**CITY OF SUNNYVALE
REPORT
Planning Commission**

February 11, 2008

SUBJECT: **2007-0822** – Application located at **734 Liverpool Way** (near Goldfinch Way) in an R-0 (Low-Density Residential) Zoning District.

Motion Appeal of a decision by the Administrative Hearing Officer approving a Use Permit to allow a modified design for an existing 9' 7" tall wood fence in the reducible front yard.

FIGURE 1

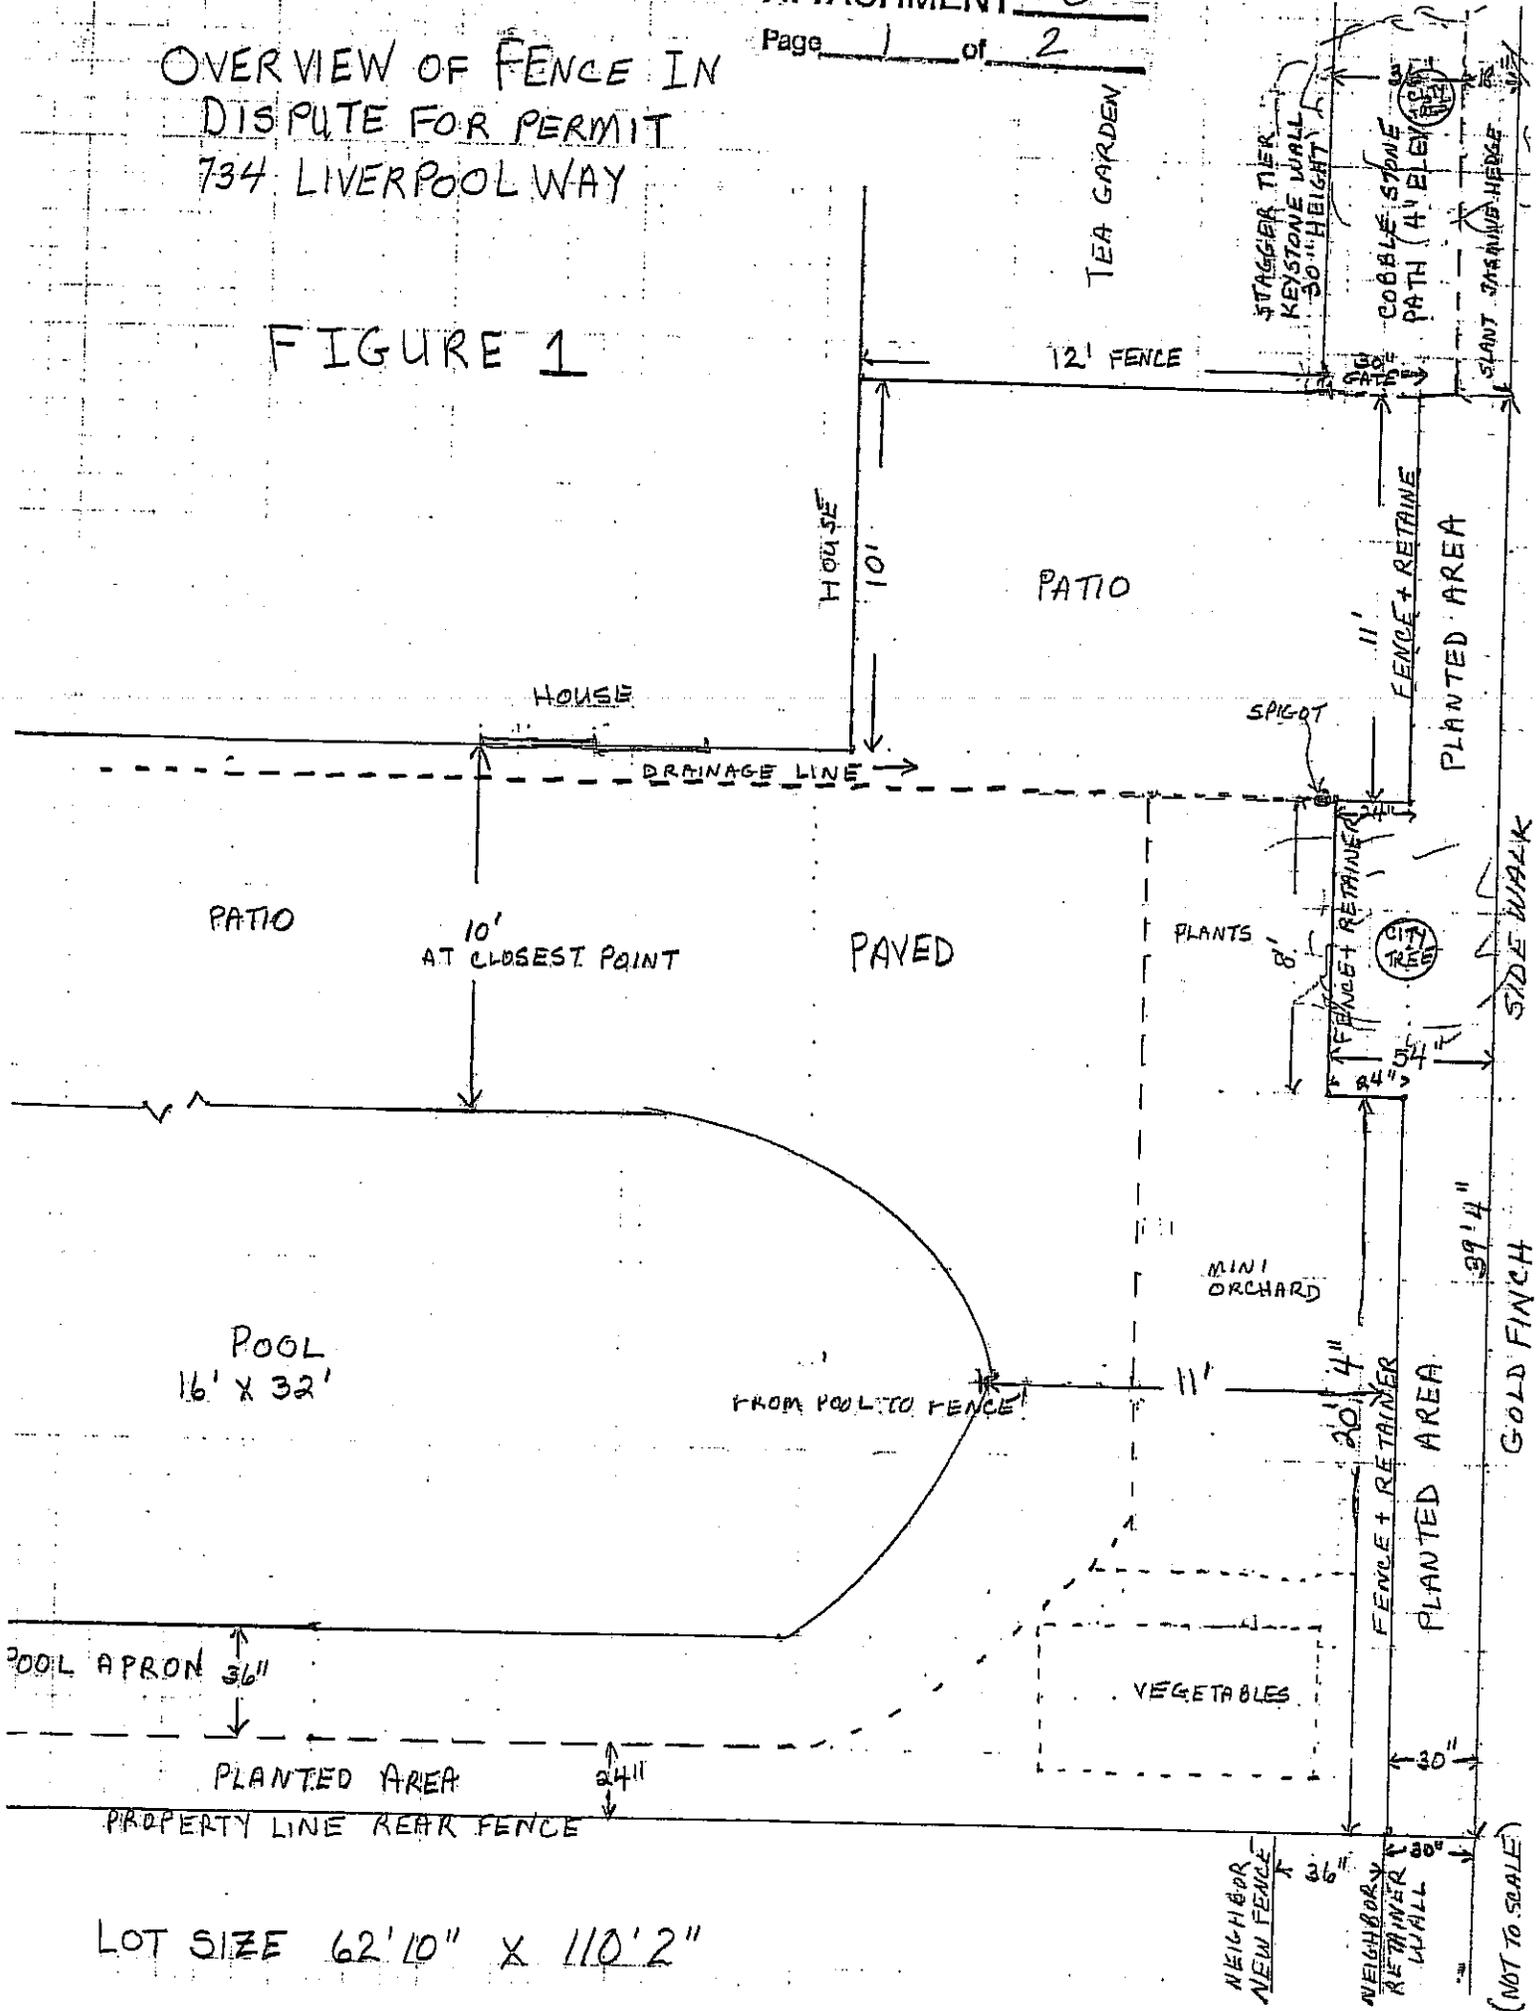
1. *The total height of the existing fence is 10', not 9' 7" as stated in the previous staff report.*

The grade of the property at the existing fence line is approximately level with the top of the adjacent public curb, but varies slightly. After receiving the appeal, staff performed additional detailed measurements across the length of the fence. Staff found the retaining wall varies from 3' 11" to 4' 2" in height, the solid board fence varies from 4' 4" to 4' 5" in height, and the lattice top measures 1' 5" in height. The resulting fence varies from 9' 7" to 10' in height as measured from the top of the adjacent curb, and is approximately 7' in height as measured from the adjacent grade on the interior of the fence. These improvements are proposed to be removed.

FIGURE 3 PROPOSED PLAN

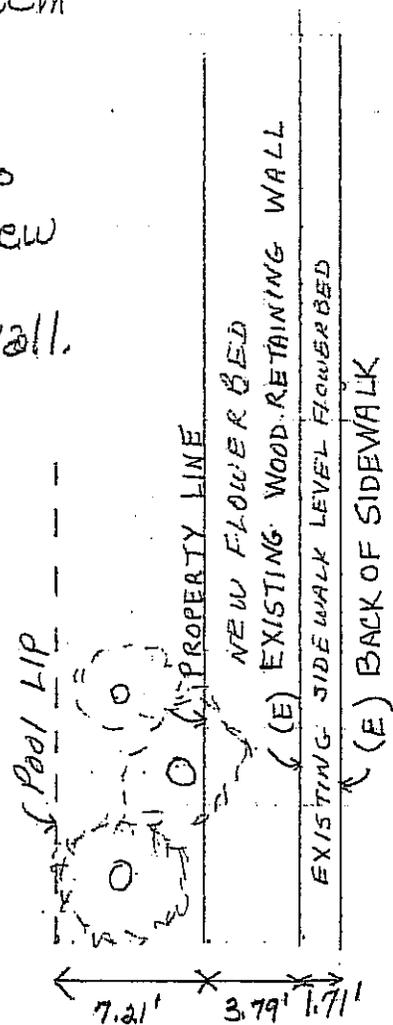
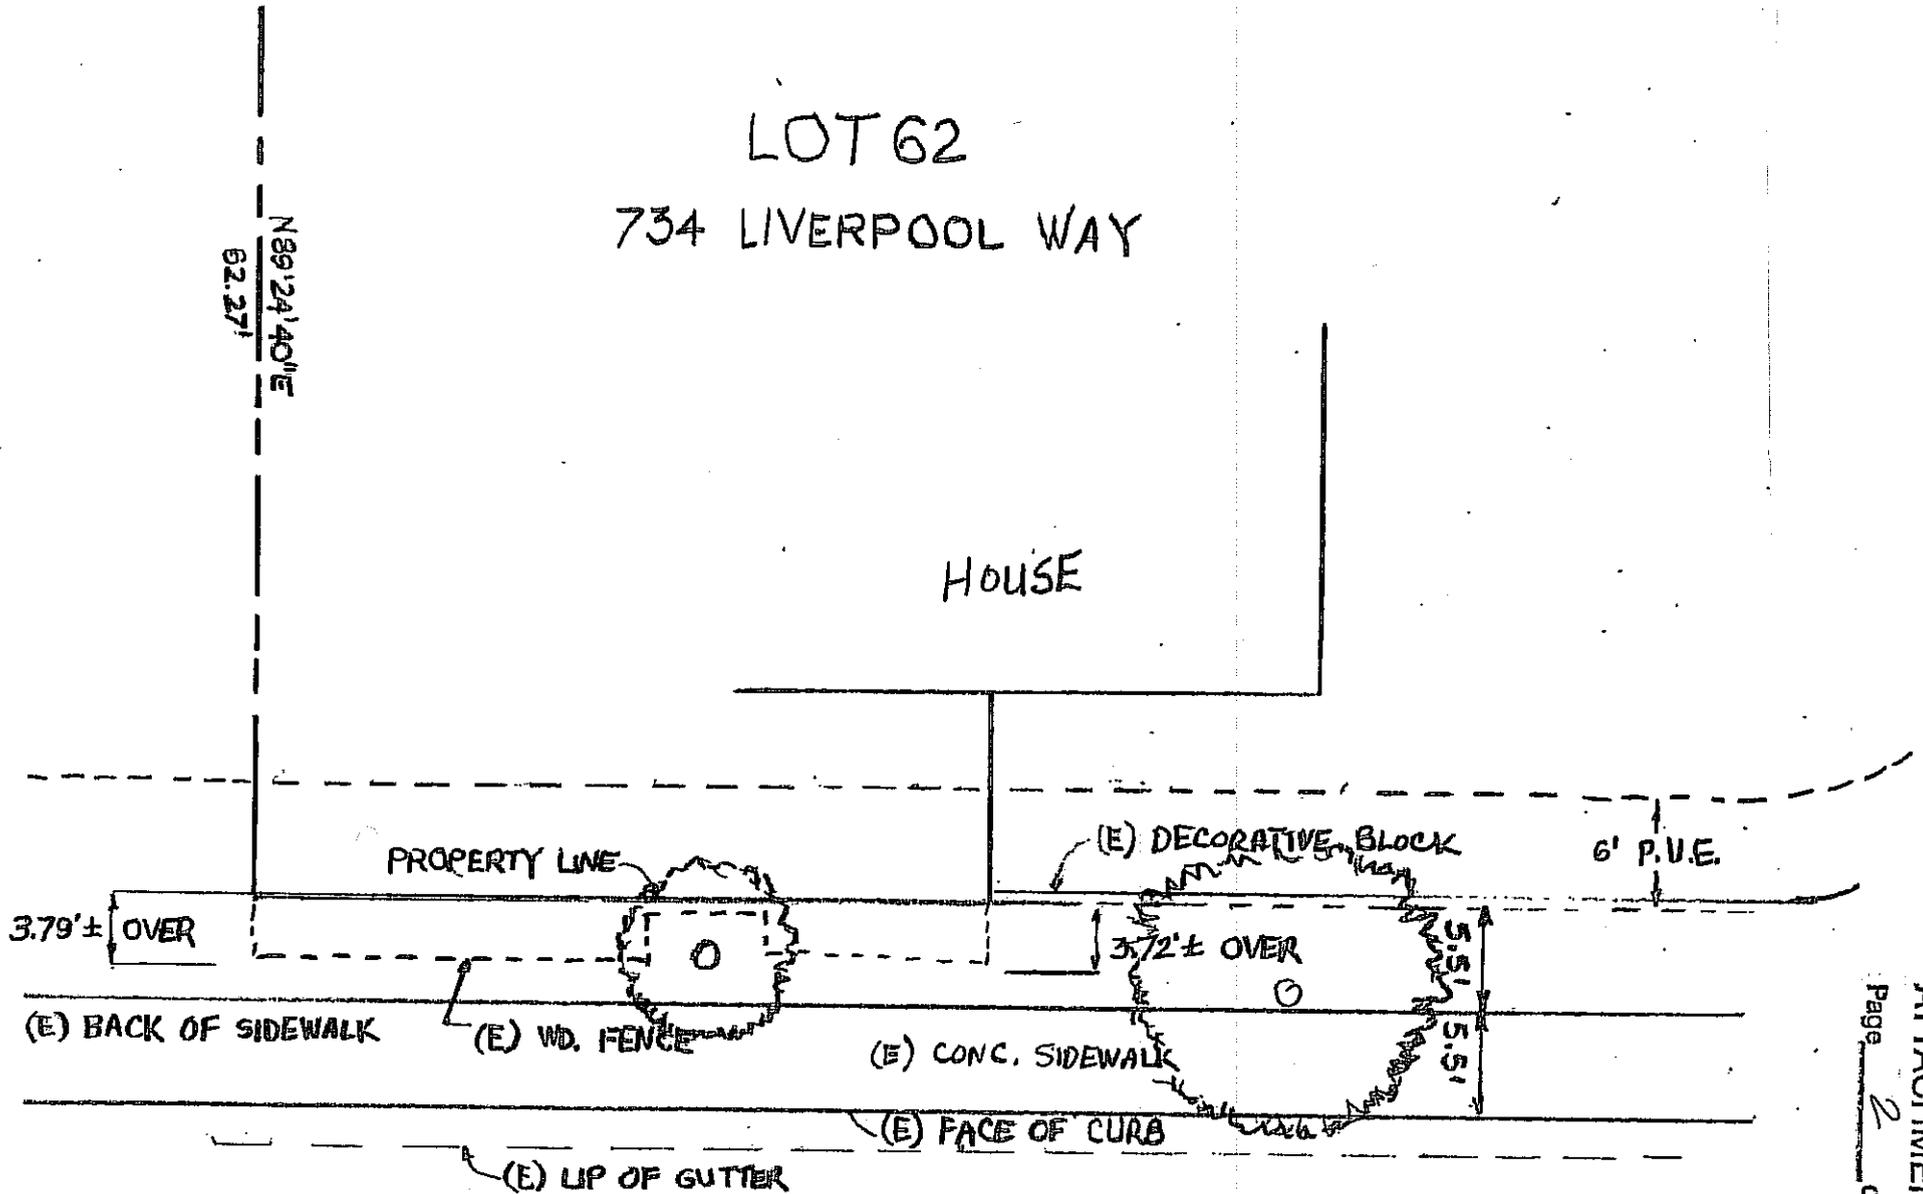
2. *The proposed plans do not clearly indicate what will be constructed.*

3. *The subject fence should be limited to no more than 8' as measured from the top of the adjacent public curb.*

5. *The plans for the retaining wall and fence should be prepared by a Licensed Structural Engineer and building permits should be required.*

Although the plans are not conventional in their presentation and may be difficult to understand, they are typical of plans provided by homeowners. Attachment D includes a cover sheet with a detailed description of the proposed modifications to the fence. The retaining wall will be maintained in its existing location, but will be reduced in height to no more than 3' as measured from the top of the adjacent public curb. The existing fence will be removed from the retaining wall, and a new fence will be constructed at least 5' 5" from the back of the public sidewalk. The new fence will consist of solid wood boards measuring 4' 6" in height with a 1' 3" lattice top, for a total height of 5' 9" as measured from the adjacent grade in the rear yard. The total height of the fence as measured from the top of the adjacent curb will be approximately equal to its current height, varying from 9' 7" to 10'.

Staff finds the design of the proposed fence as shown in Attachment D to be consistent with the Single Family Home Design Techniques. Although the height of the fence as measured from the top of the curb is taller than the maximum height recommended in the Design Techniques, the proposed fence would be set back significantly from the sidewalk. This setback, combined with the landscaping required by Condition of Approval #3C, would mitigate the visual impacts of a taller fence and prevent a walled-in appearance. Staff notes

Building permits are required for the retaining wall because its height is greater than 4' as measured from the bottom of the footings. The Building Safety Division does require plans for retaining walls over 4' in height to be prepared by a Licensed Structural Engineer. Building permits are not required for fences with heights less than 6' as measured from the adjoining grade unless they are located directly atop a retaining wall, therefore no building permit is required for the proposed fence.
